## SHELTER BAY ANIMAL HOSPITAL JSP21-27

Public Hearing at the request of Other Work, LLC, for approval of the Special Land Use and Preliminary Site Plan. The subject property is approximately 3.15 acres and is located south of Twelve Mile Road and west of Haggerty Road in the B-3, General Business, Zoning District. A use agreement was recently amended to allow this site to be considered for use as a veterinary clinic, veterinary hospital, and catering kitchen. The applicant is proposing to renovate the interior of a former Ruby Tuesday restaurant and some minor exterior site renovations including parking lot restriping, the addition of end islands, and the designation of an outdoor area for animals.

# PLAN REVIEW CENTER REPORT

## Planning Review

**SITE LAYOUT AND MATERIALS PLAN**

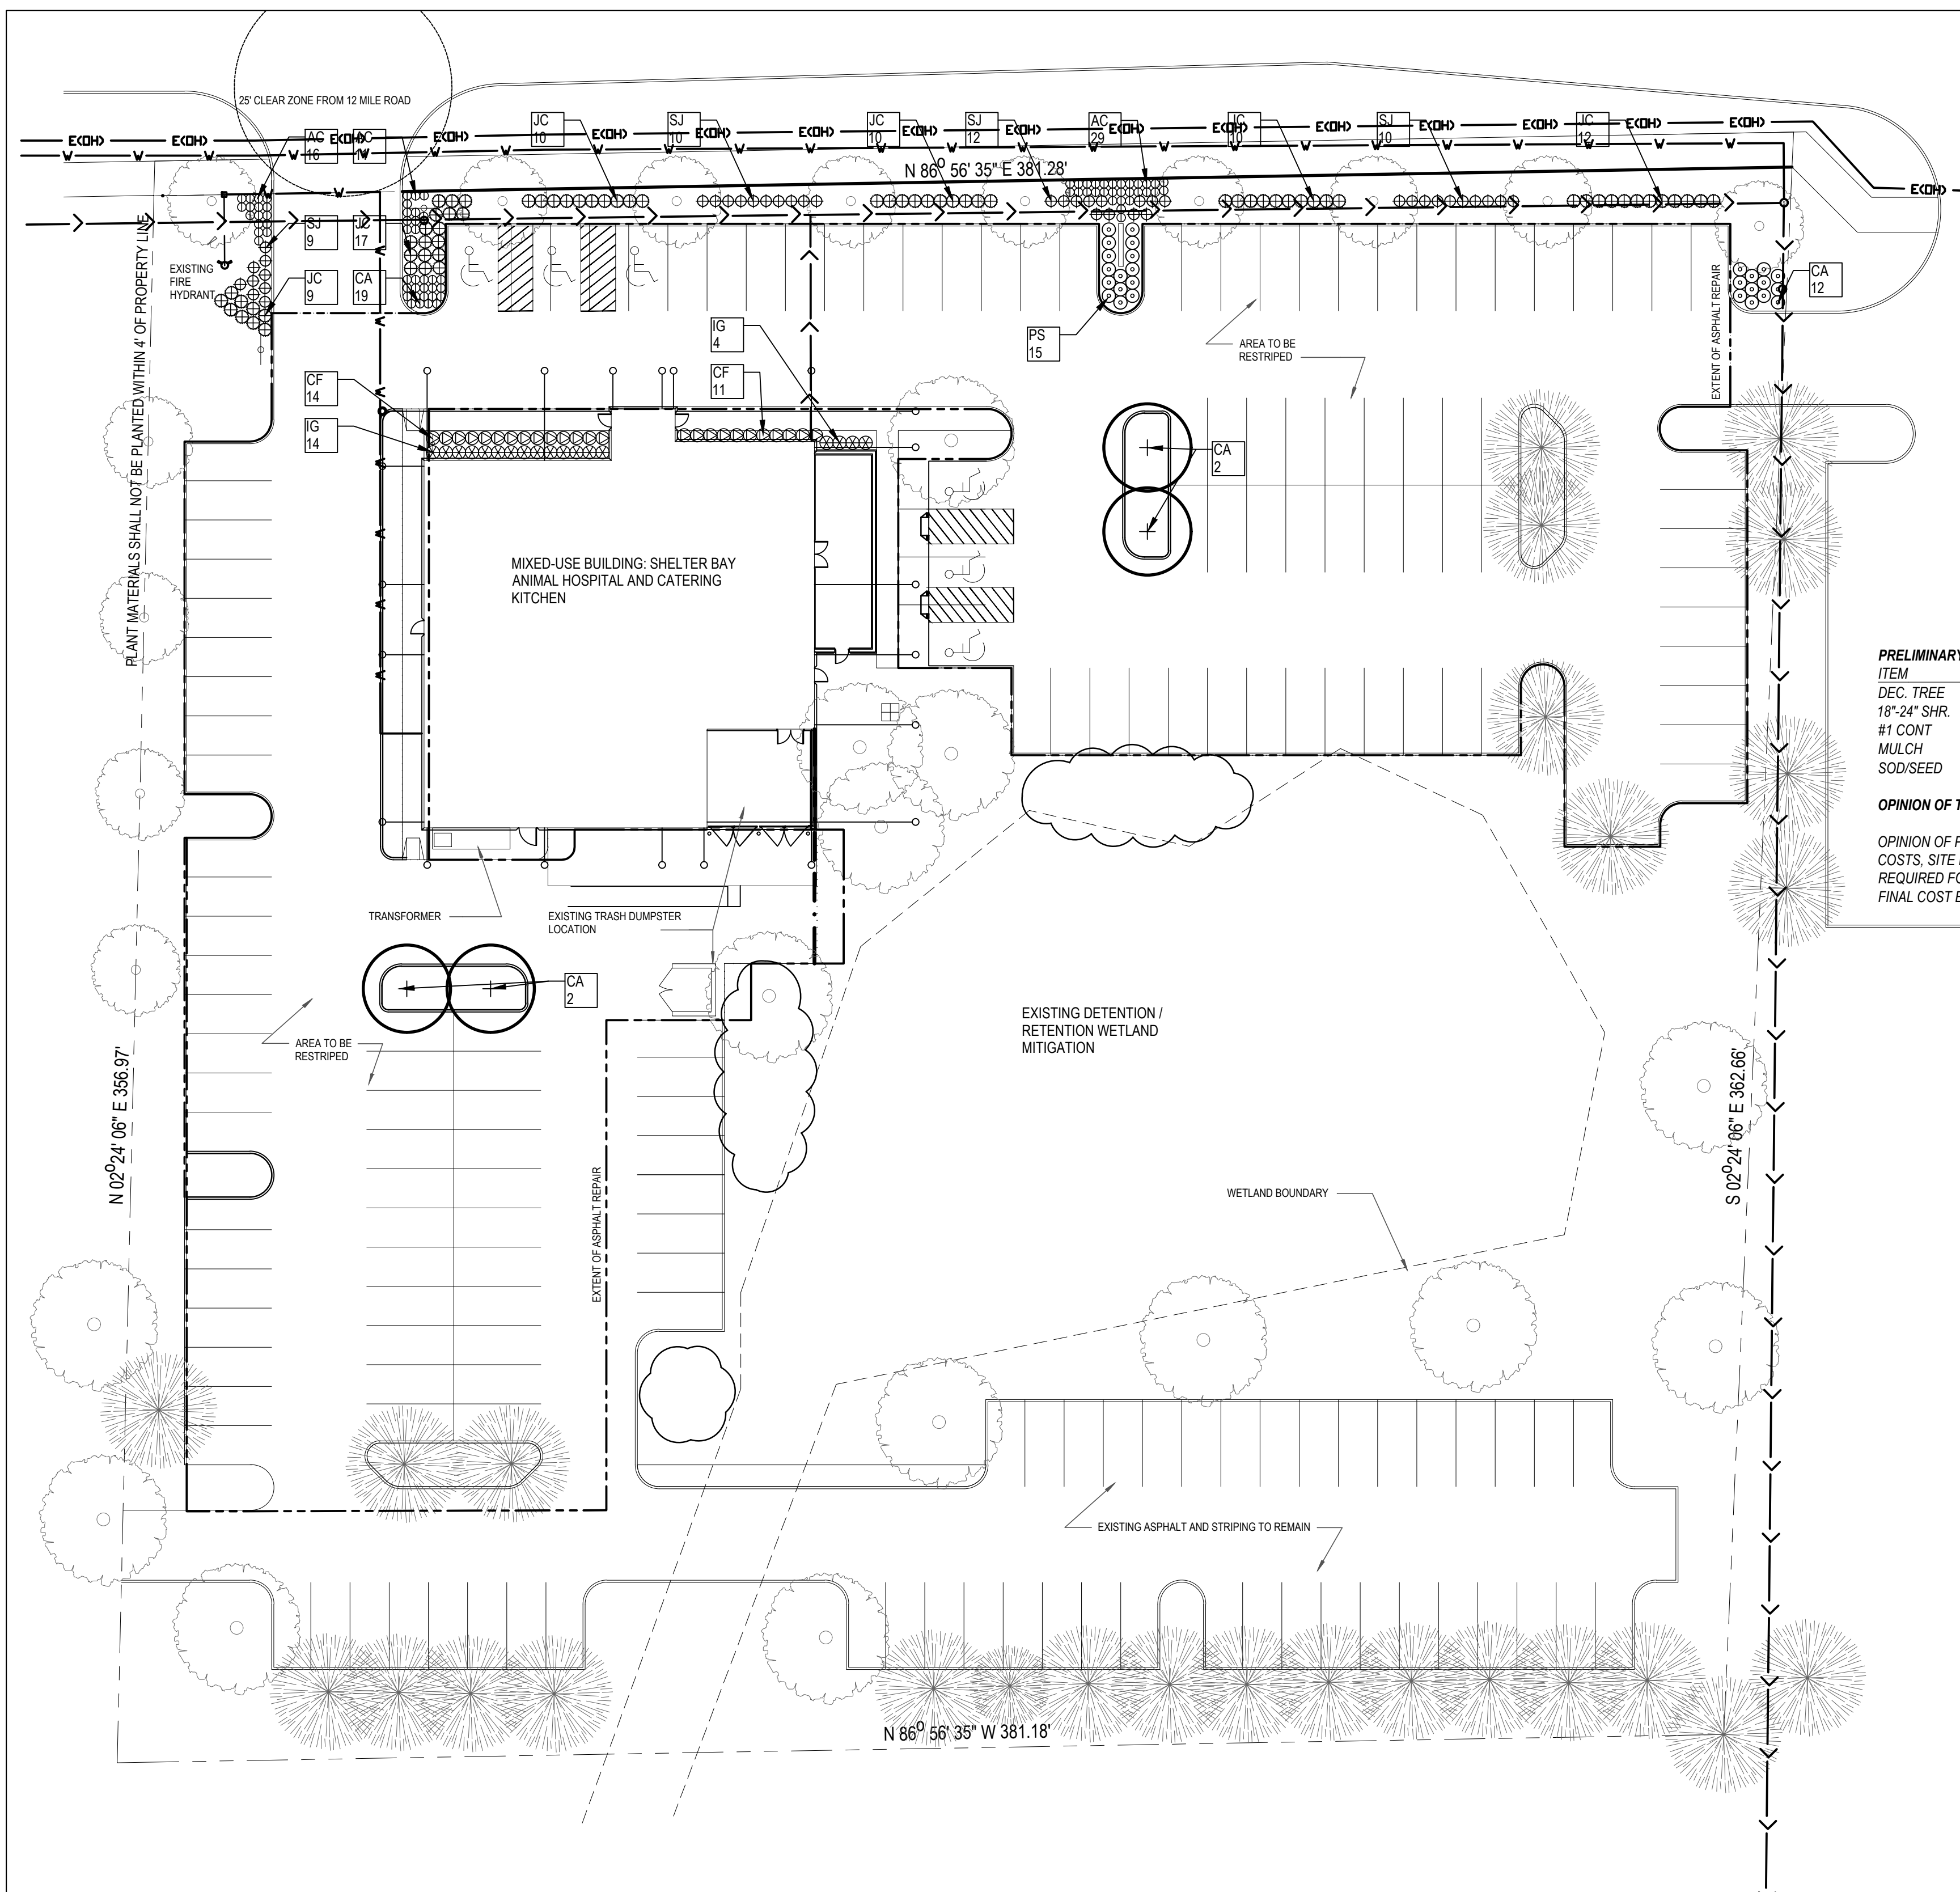
3. Pick-Up Parking Spaces and Loading Zone (Sec. 3.10.3.A): The proposed plan does not indicate if any designated pick-up spaces would be needed for the ghost or catering kitchen. However, a loading zone for catering is indicated near the rear of the building that blocks the gates to the dumpster enclosure and it is unclear how the space will be used. **Please clarify and revise the loading zone as necessary, provide the location of any proposed pick-up spaces, and verify that a separate entrance will not be needed for the ghost/catering kitchen with the Building Department. The response letter indicates that the proposed pick-up spaces will be shown on Sheet L2.0.0 with the next submittal.**

We will show the proposed pick-up space on L2.0.0

**ARCHITECTURAL SITE PLAN - OVERALL**

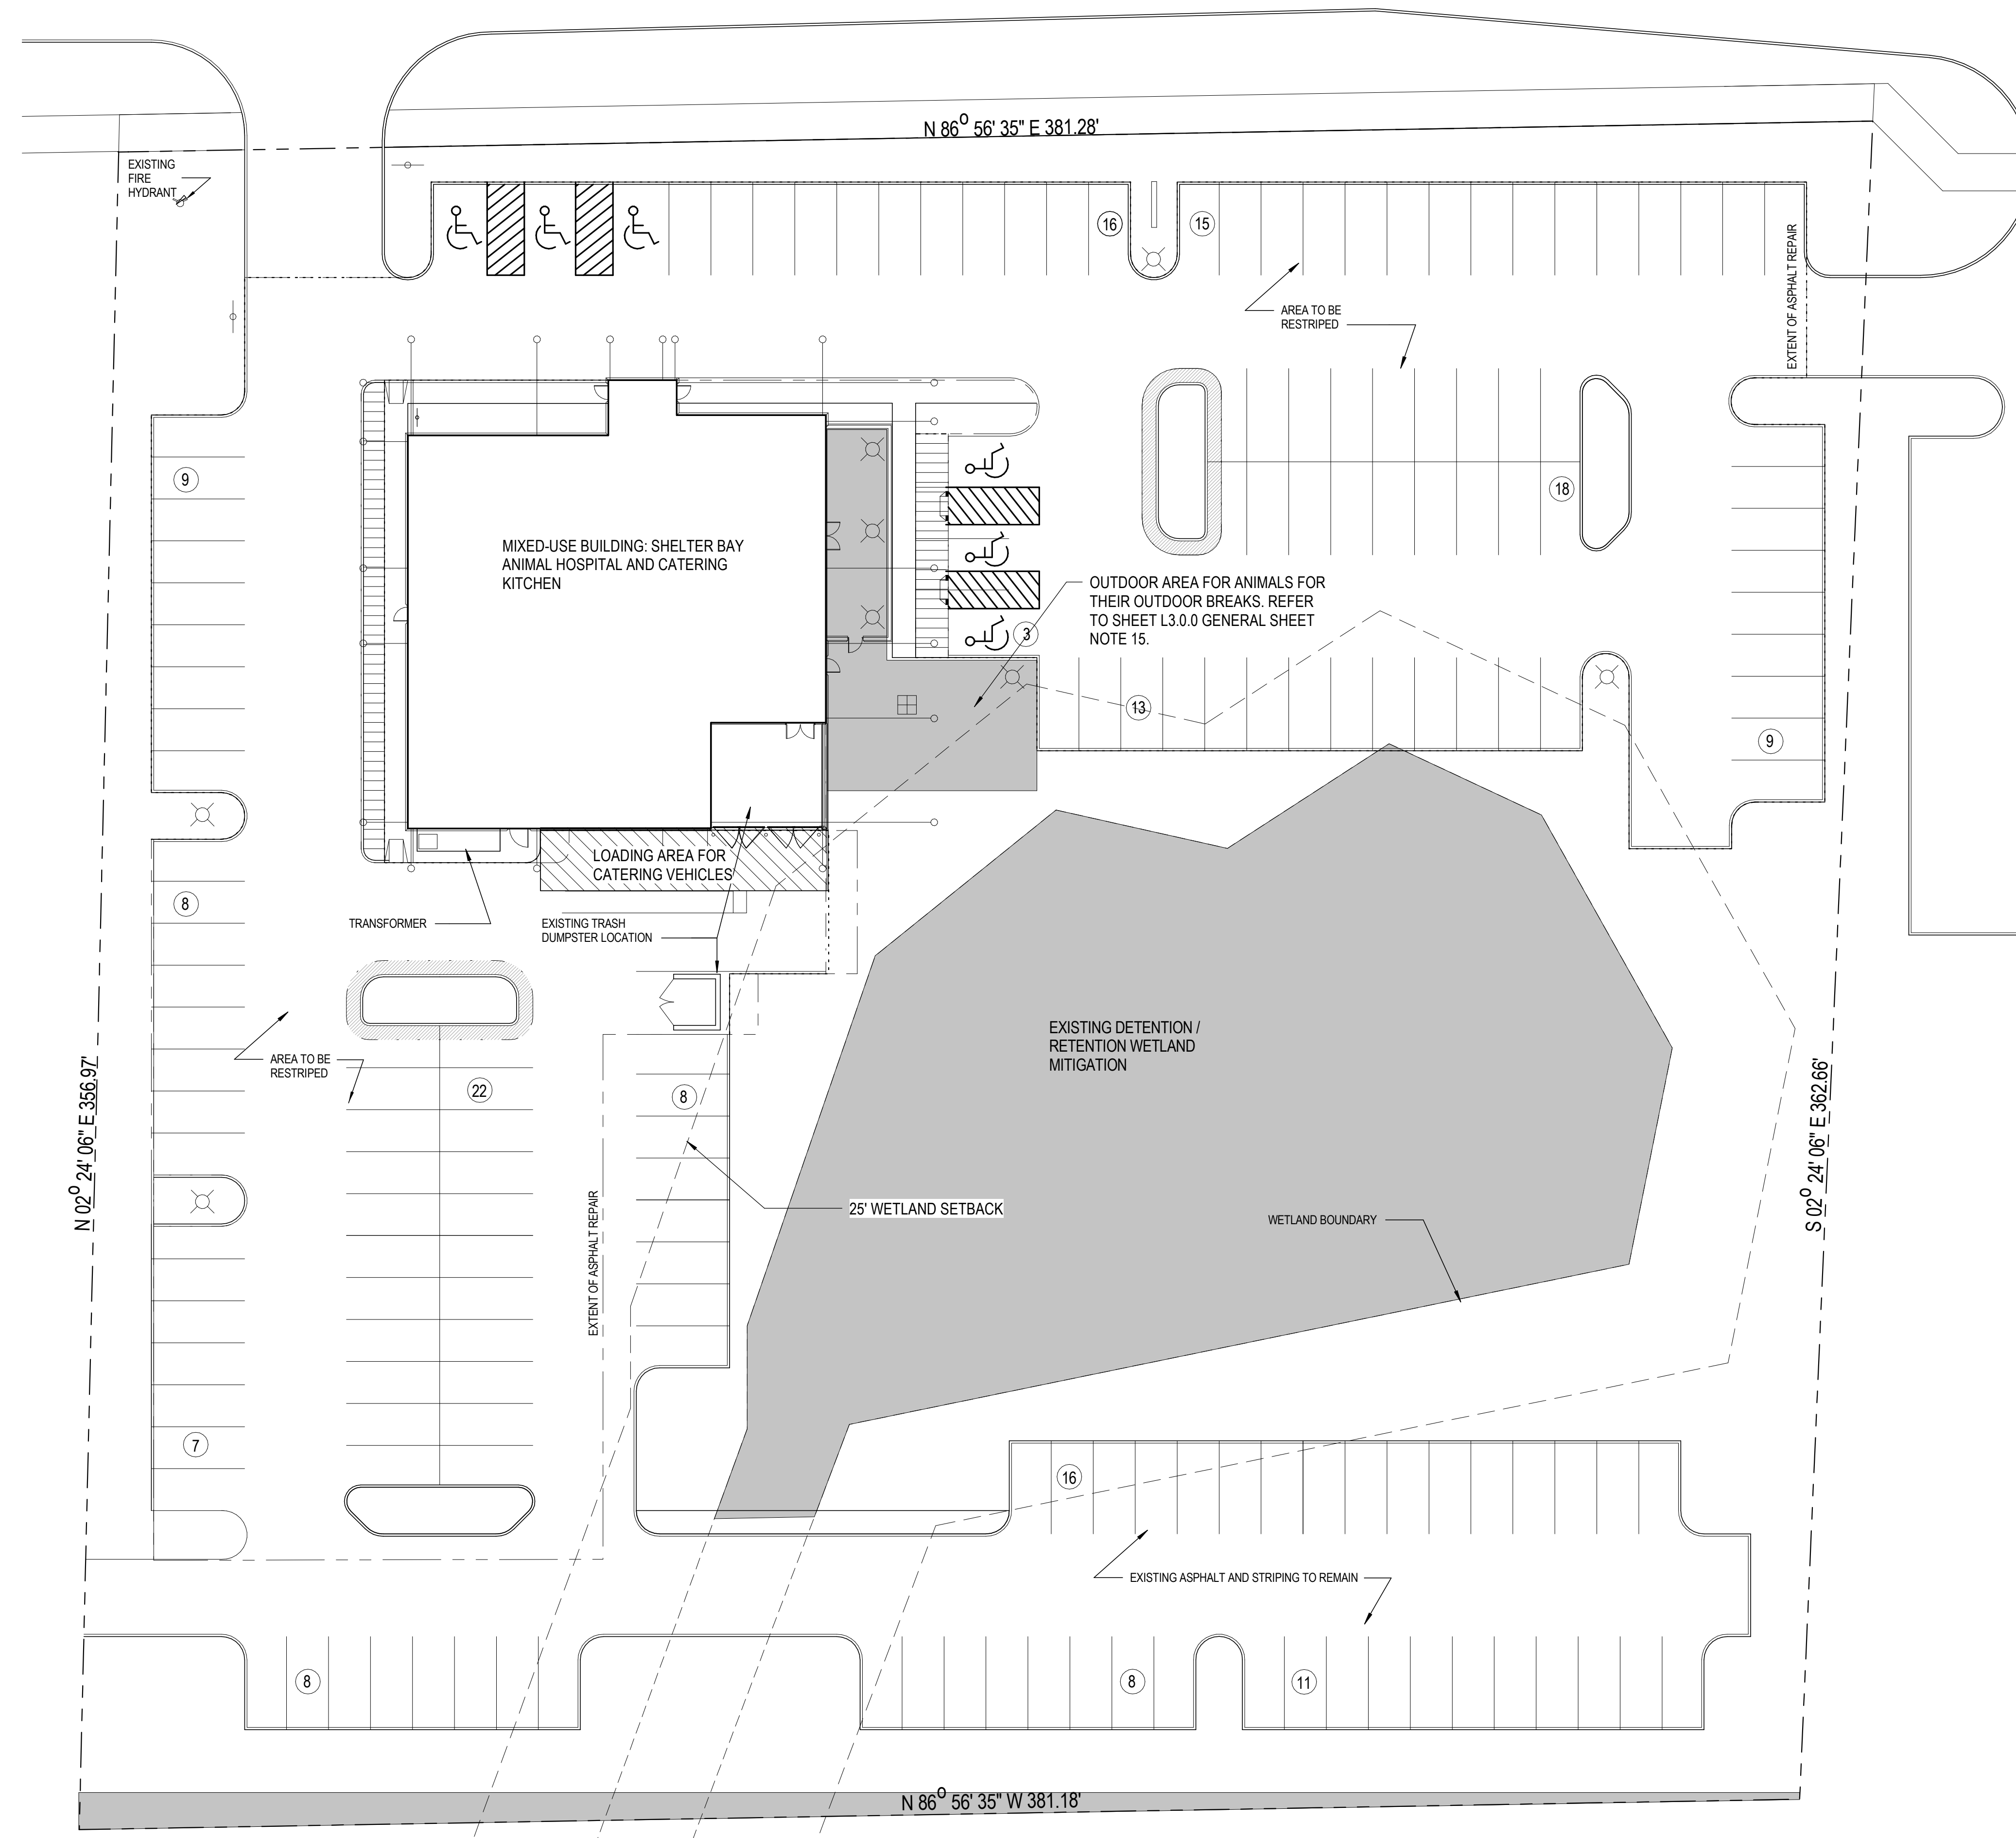
4. Outdoor Area (Sec. 4.31.1): The outdoor area indicated on Sheet L3 is labeled incorrectly. **Please label this correctly with the next submittal. The response letter indicates that this will be addressed with the next submittal.**

**There is no sheet L3. Nor can we find an outdoor area note labeled incorrectly on any of the Landscape sheets. Outdoor note labeled on A1.1.1, and the reference to L3.0.0 will be revised.**

2 EXISTING DUMPSTER ENCLOSURE PLAN  
 SCALE: 1/8" = 1'-0"

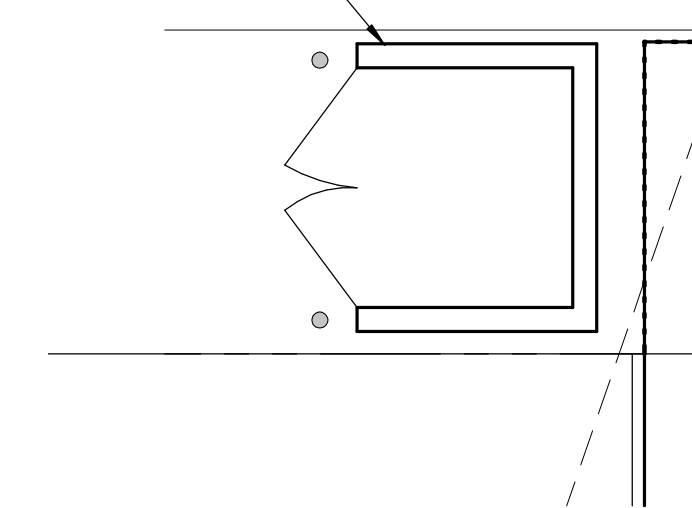
8. Dumpster Enclosure (Sec. 21-145 (c)): The Dumpster Enclosure appears to be remaining the same. **However, please provide a detail of the dumpster enclosure to verify that the materials match the façade of the building to the extent possible. The response letter indicates that this request will be addressed on the next submittal.**

The dumpster enclosure remains existing, with the same materials as the facade. We will provide a note on the drawings indicating the existing, matching condition on Sheet A1.0.0
